Addendum 3

Client: Creswell School District
Project: CHS Academic Building Improvements (Primary) Project
Date: March 11, 2026
To: Interested Bidder
Prepared by: Curt Wilson, AIA; Principal, Wilson Architecture

This Addendum modifies the Project Manual, Specifications, and Drawings as follows:

1 FLOOR PLAN AREA A - TECHNOLOGY
T1.10 1/8" = 1'-0"

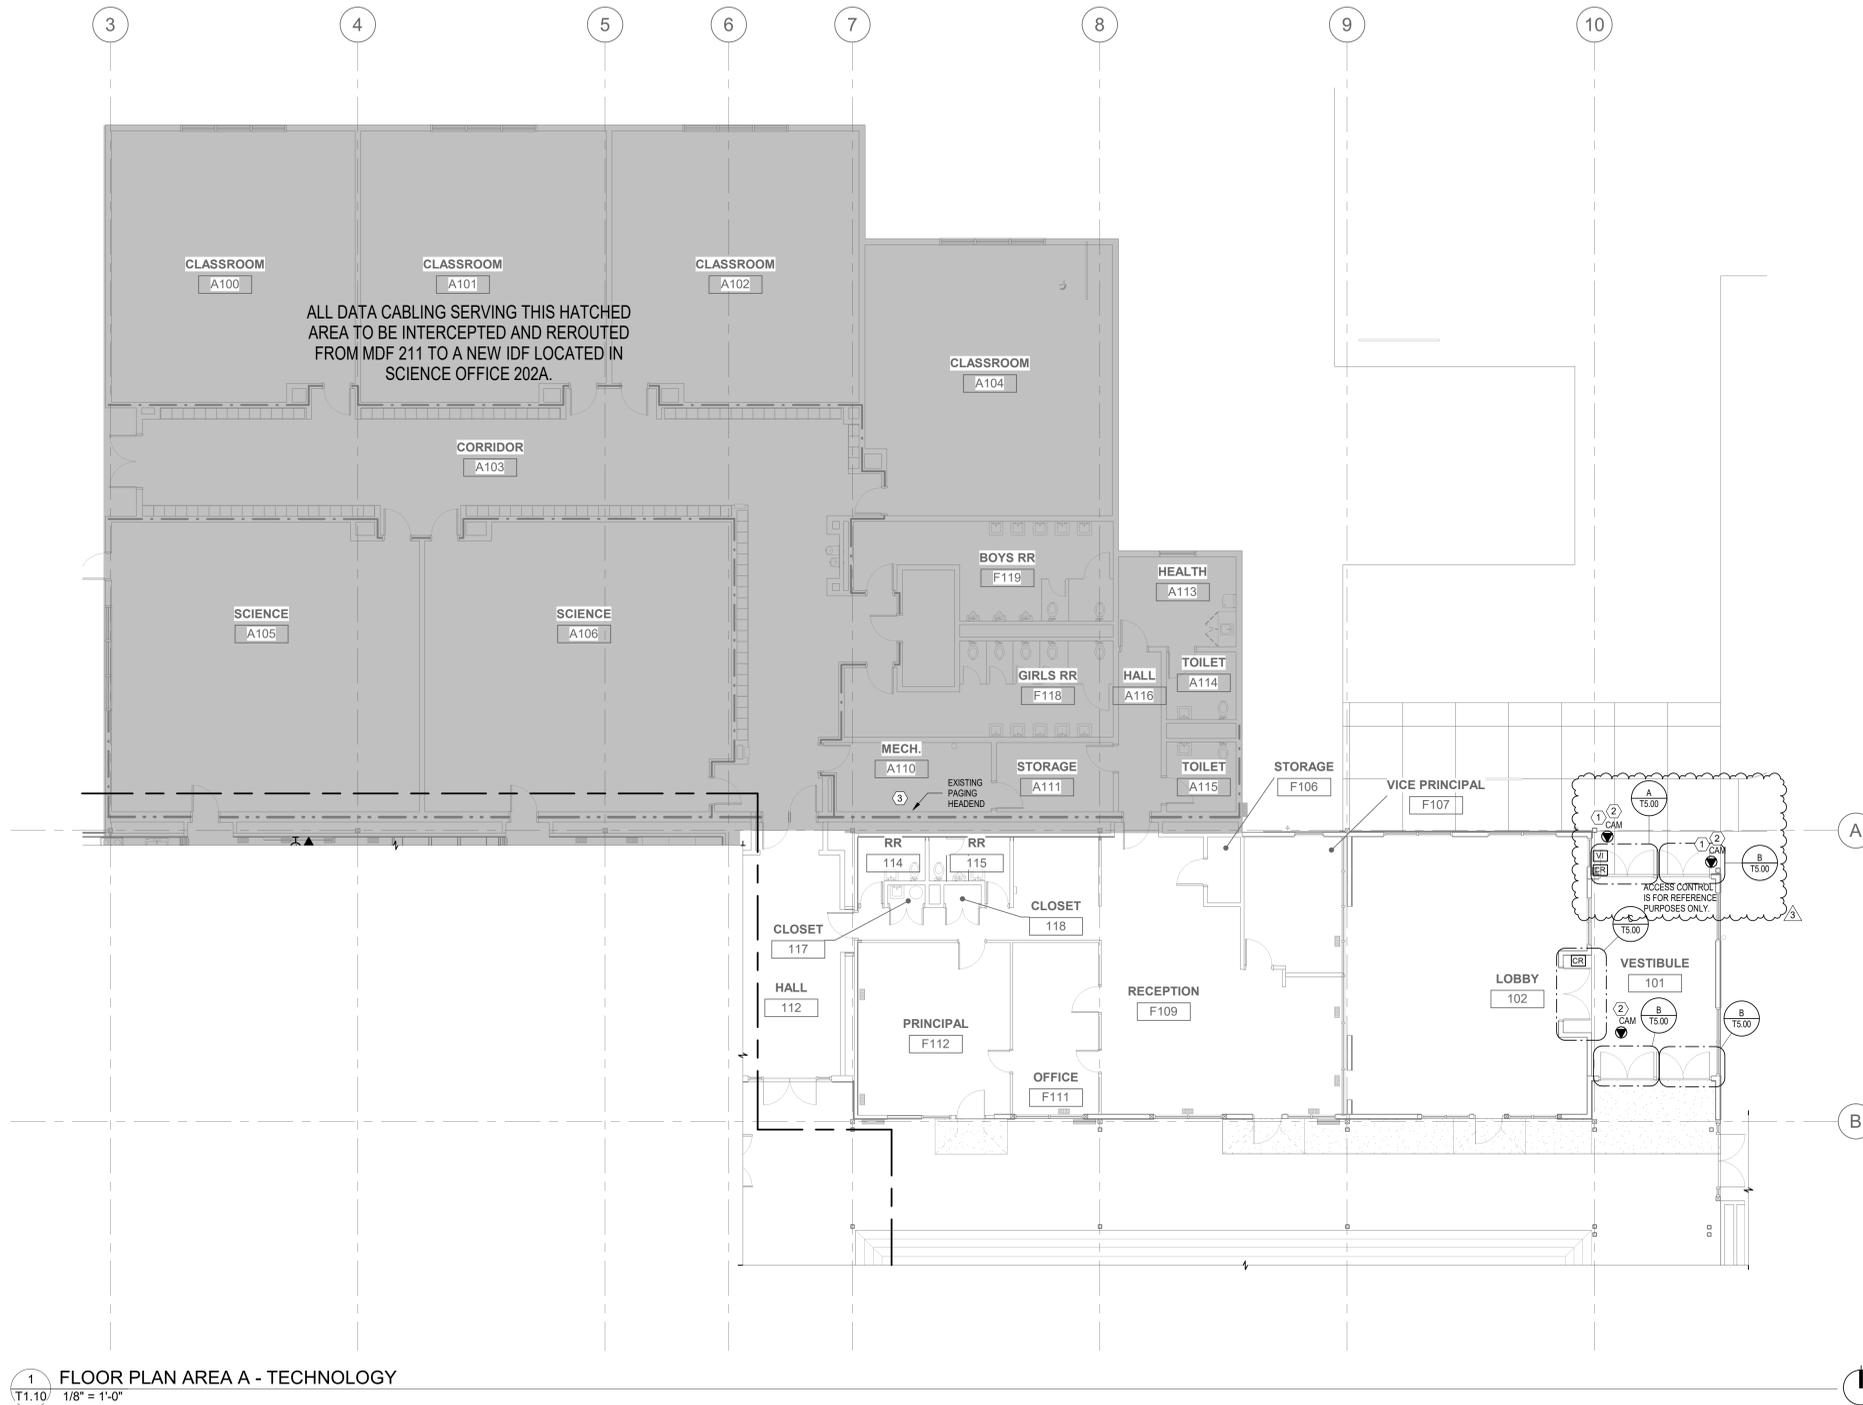
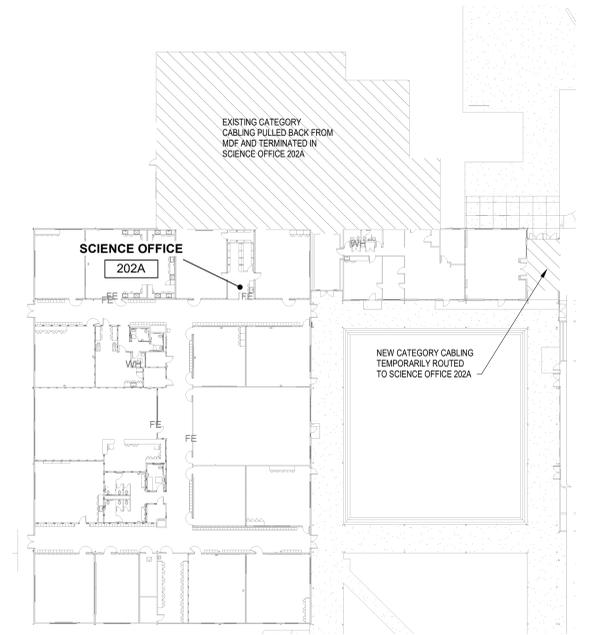
- Access control/security management notes updated for access control work by TI Project.
- 3.25. Sheet T1.10 - Floor Plan - Area B - Technology
- a. Replace original sheet with attached version. A brief summary of the changes include:

- “ACCESS CONTROL IS FOR REFERENCE PURPOSES ONLY” note added to Rm 101 – Vestibule.
- 3.26. Sheet T1.12 - Floor Plan - Area B - Technology
- a. Replace original sheet with attached version. A brief summary of the changes include:

1 FLOOR PLAN AREA B - TECHNOLOGY
T1.12 1/8" = 1'-0"

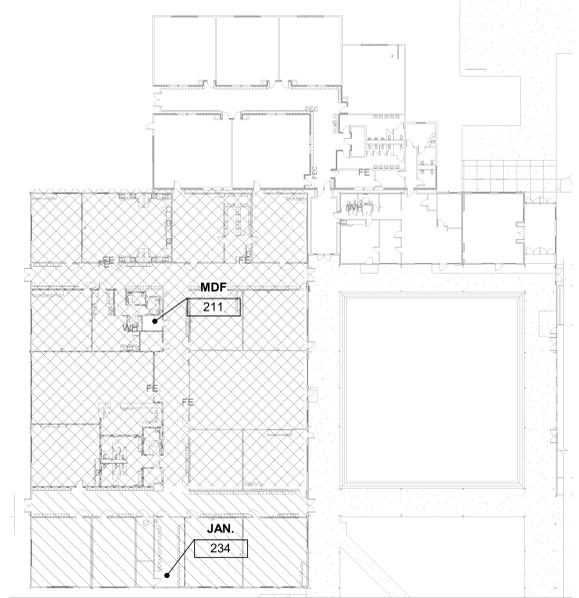
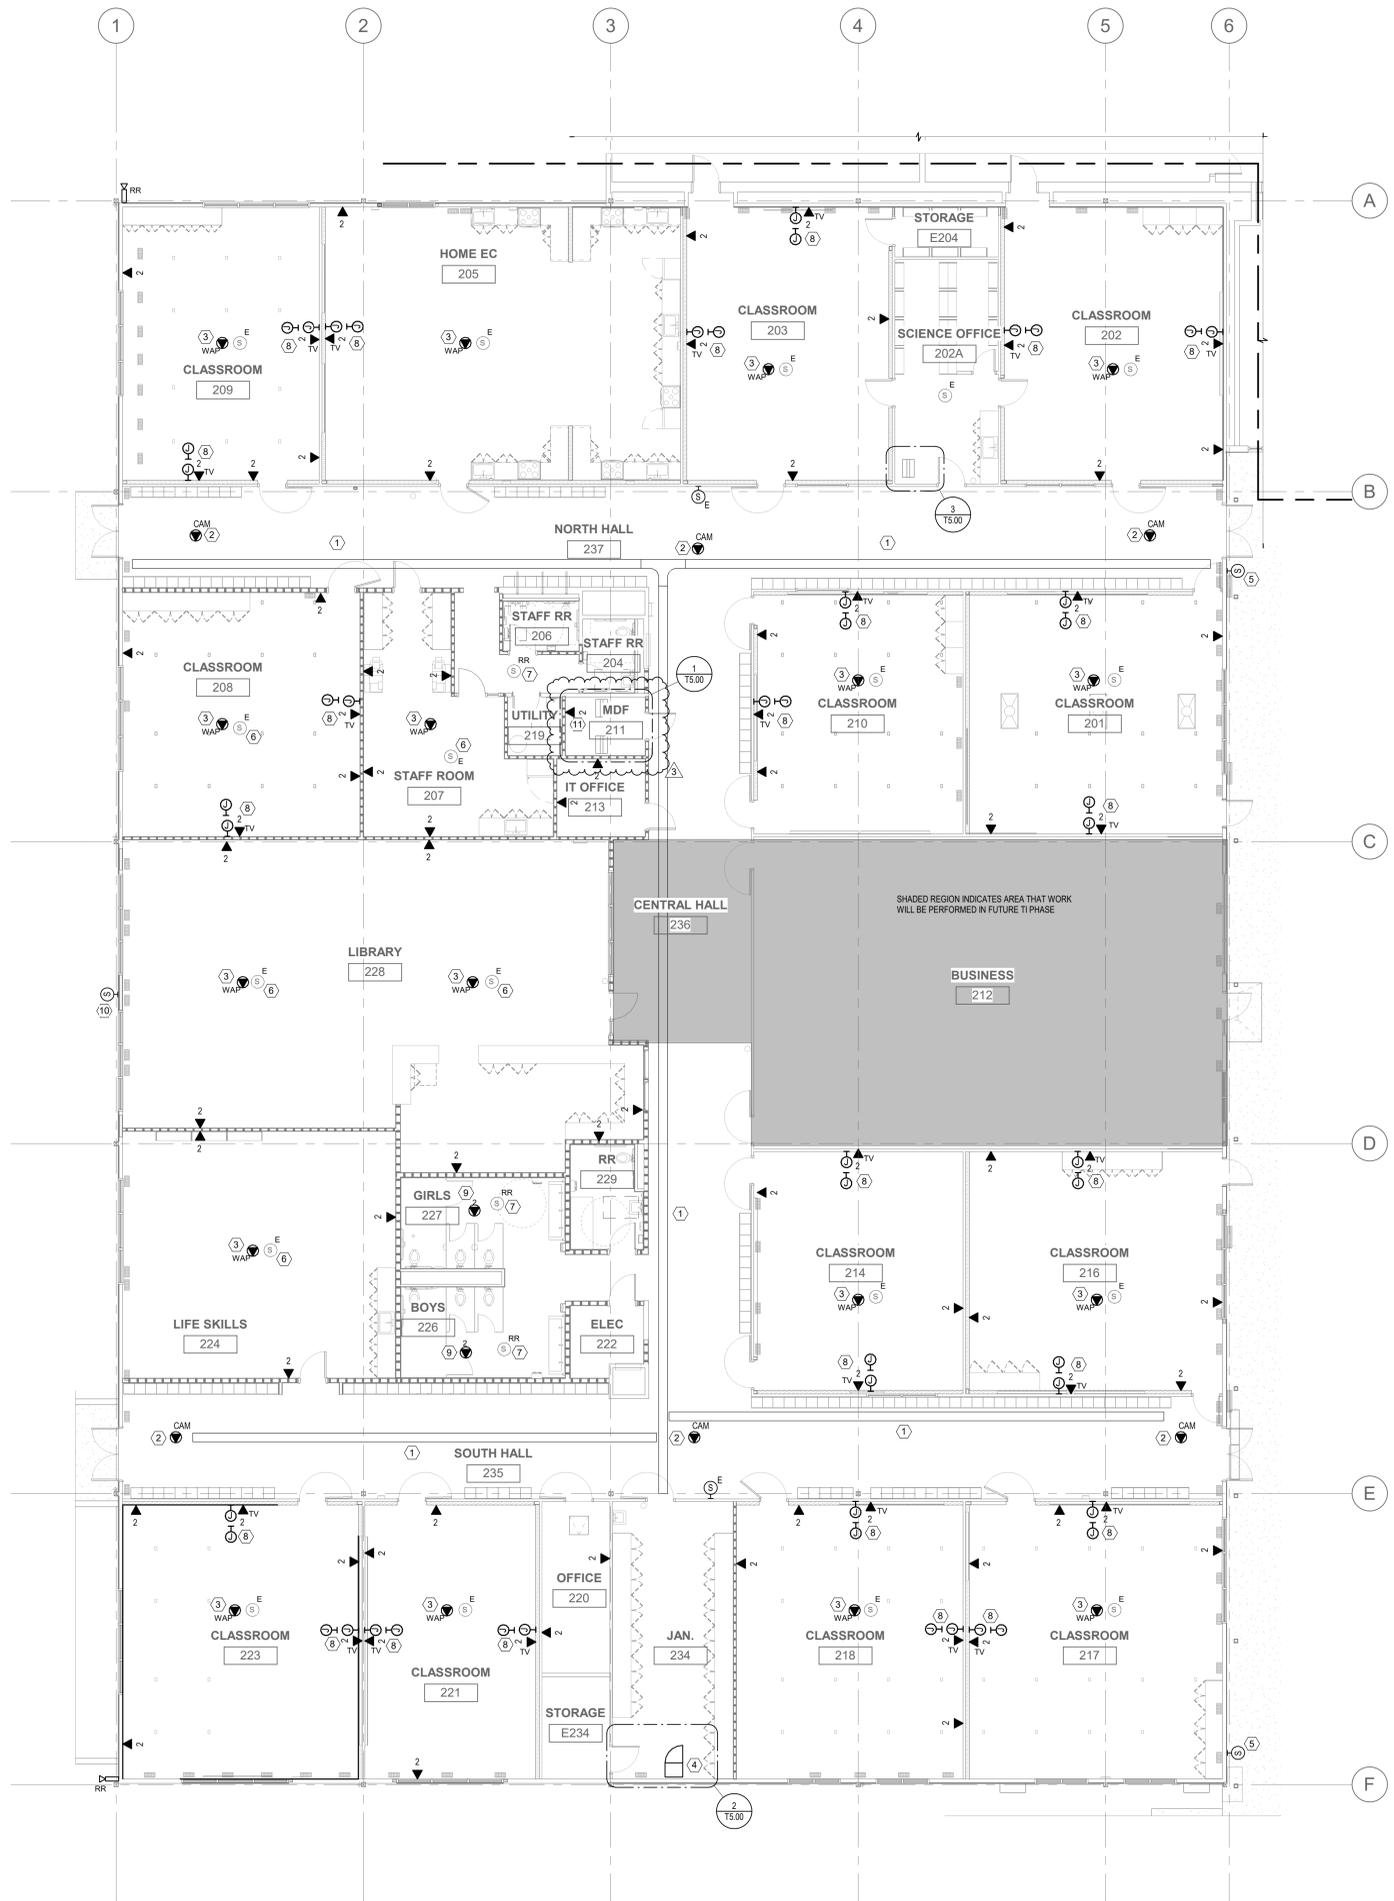
- MDF 211 - ADD data location for mechanical controls system.
- 3.27. Sheet T5.00 - Technology Details
- a. Replace original sheet with attached version. A brief summary of the changes include:
